From:
To: [Planning](#)
Subject: Re: NYM/2021/0332/FL
Date: 28 May 2021 11:21:28

proposed development scheme for the grainary harewood dale - scale 1:100@A3

proposed ground floor layout and elevation

AMENDED

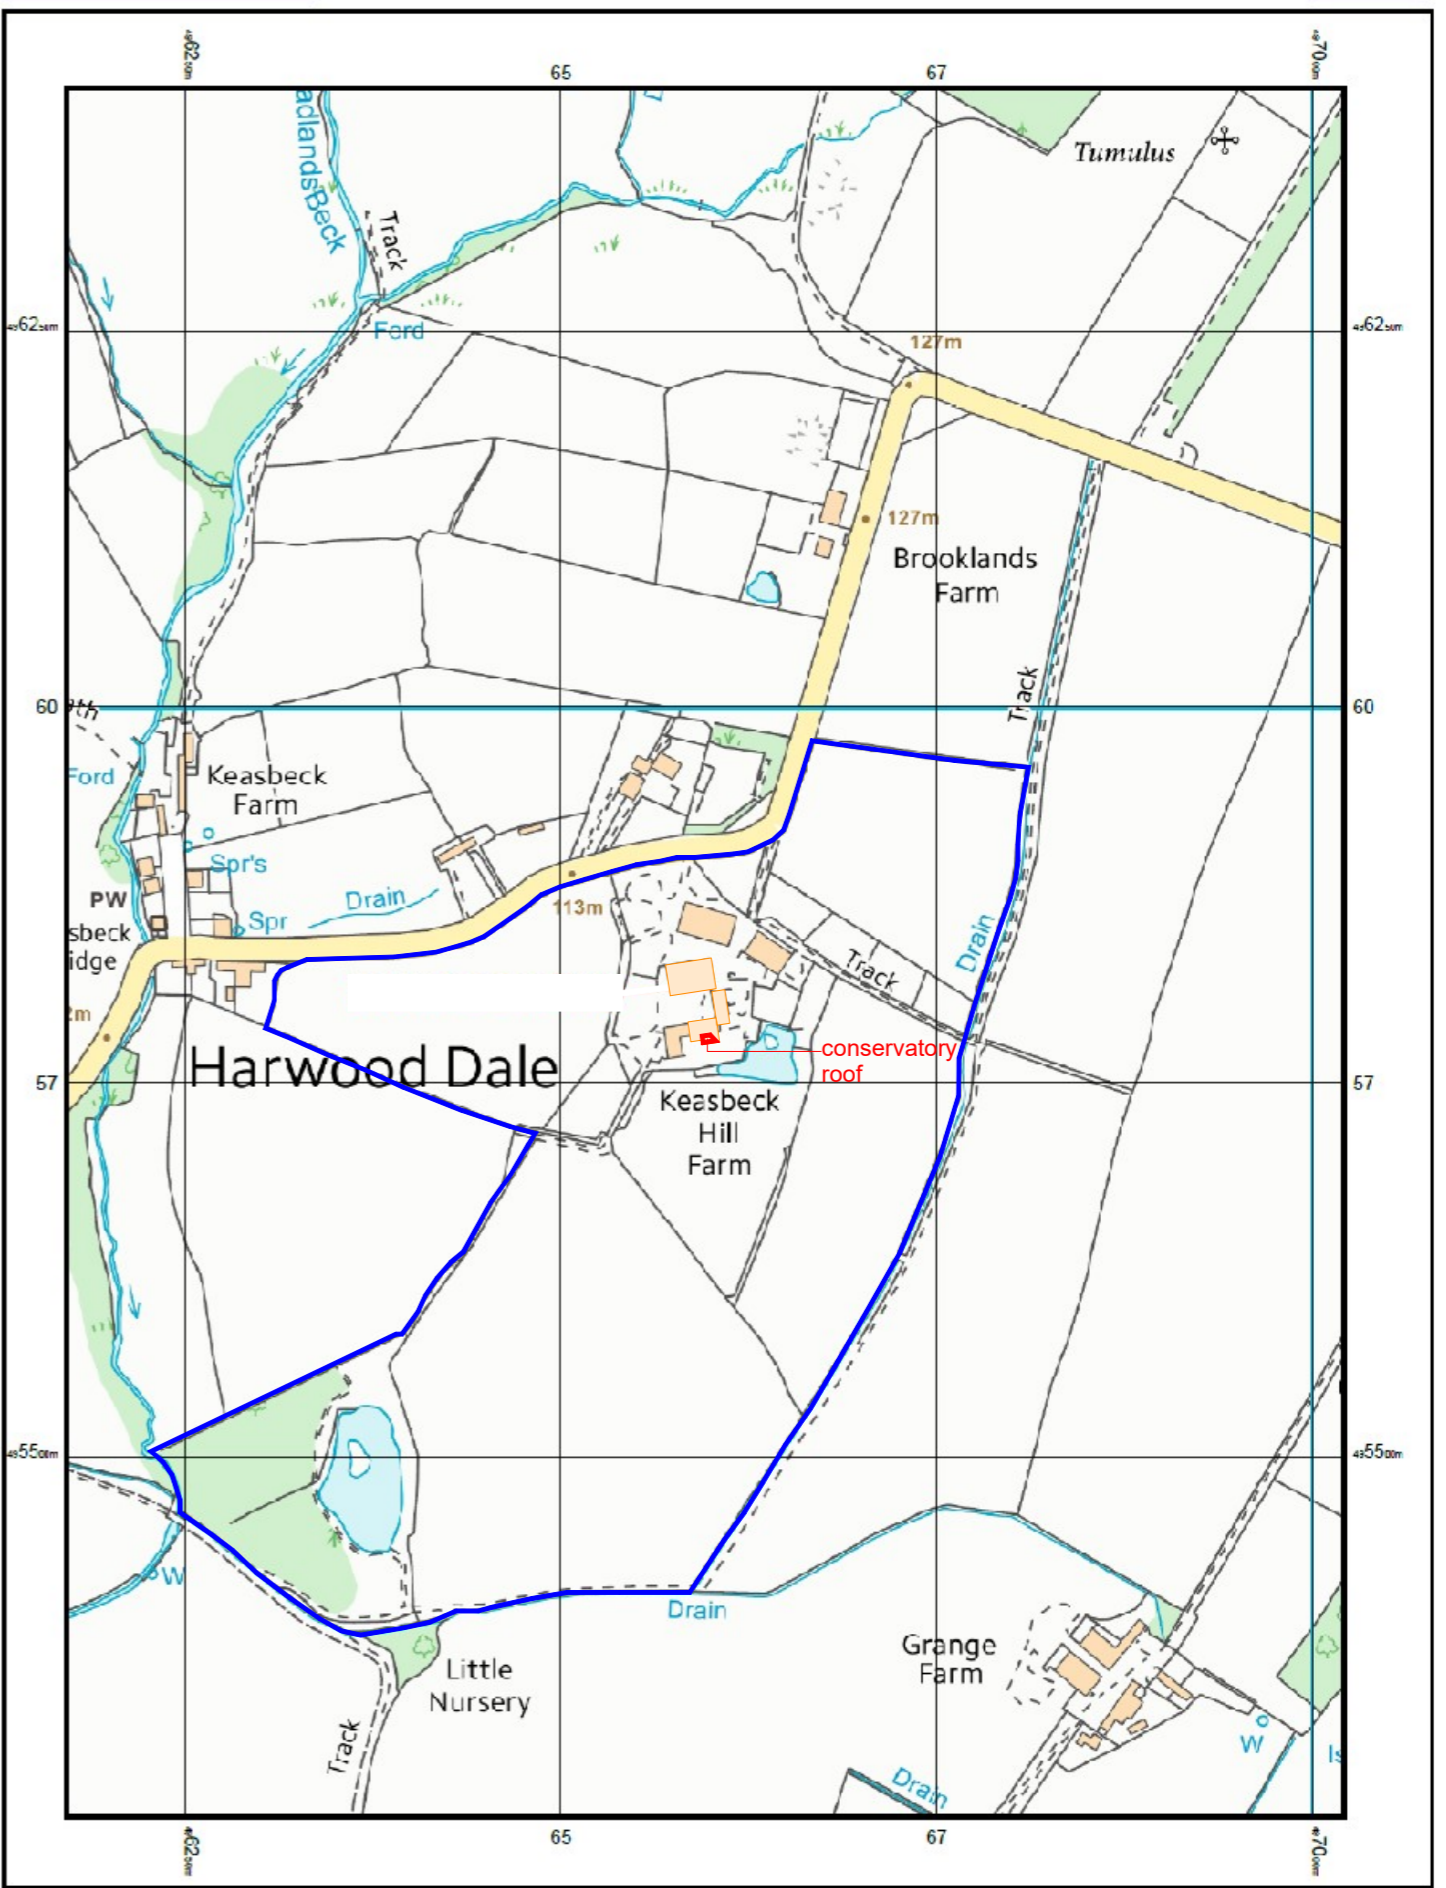
hi - thank you for the email and I now have the information and attach the revised location and block plan showing ownership with a blue line
I also attach the drawing showing the pantile roof with velux conservation rooflights in for additional light at the rear that the applicant would like to include in the application - and please contact me if you require any further information - thanks for the help - regards
mick

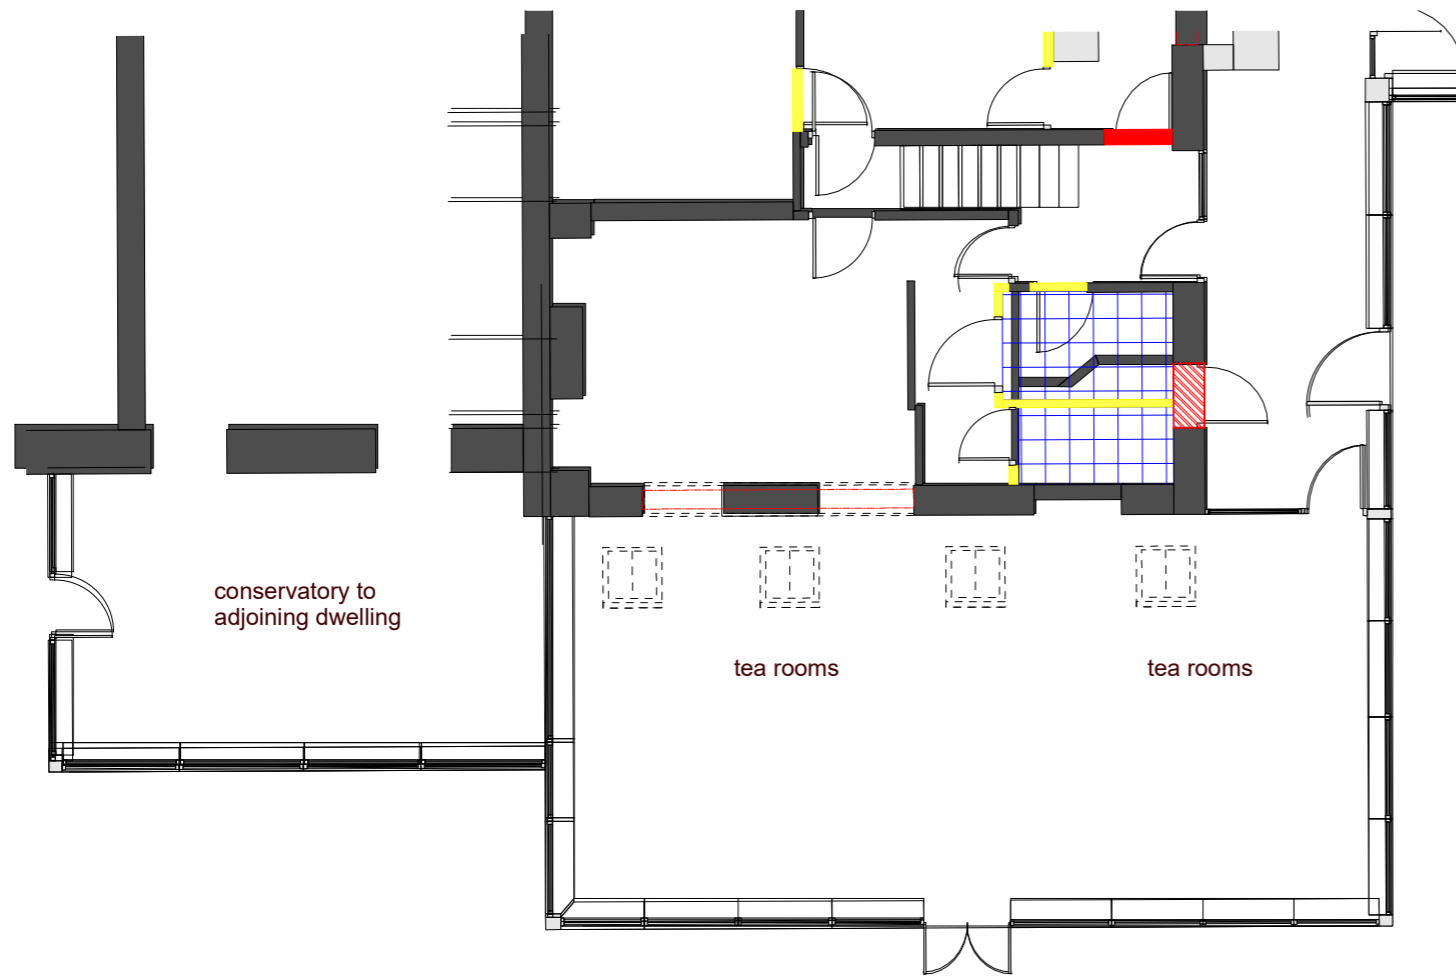
existing polycarbonate roof to be removed and replaced with pantile roof

velux conservation rooflights 1180 x 780

existing polycarbonate roof to be removed and replaced with pantile roof to match the rest of the existing buildings

Roof construction to comprise clay pantiles on a vapour permeable barrier (eg. Marley Ultima PR) or similar with treated timber laths 50 x 35 and with 120mm Celotex FR5000 between rafters and 50mm thick Celotex FR5000 below rafter and 500 gauge polythene vapour check with 12.5mm gypsum plasterboard and skim. All to give a U-value of 0.16 W/m²k
 existing built up timber roof retained
 All tiles including eaves, ridge and verges to be nailed/clipped
 roof members to be secured using proprietary anchors, clips and fixings all in accordance with specialist recommendations
 Note: no notches or holes to be cut in roof rafters other than at supports where they may be birdsmouthed to a depth not exceeding 1/3 rafter depth
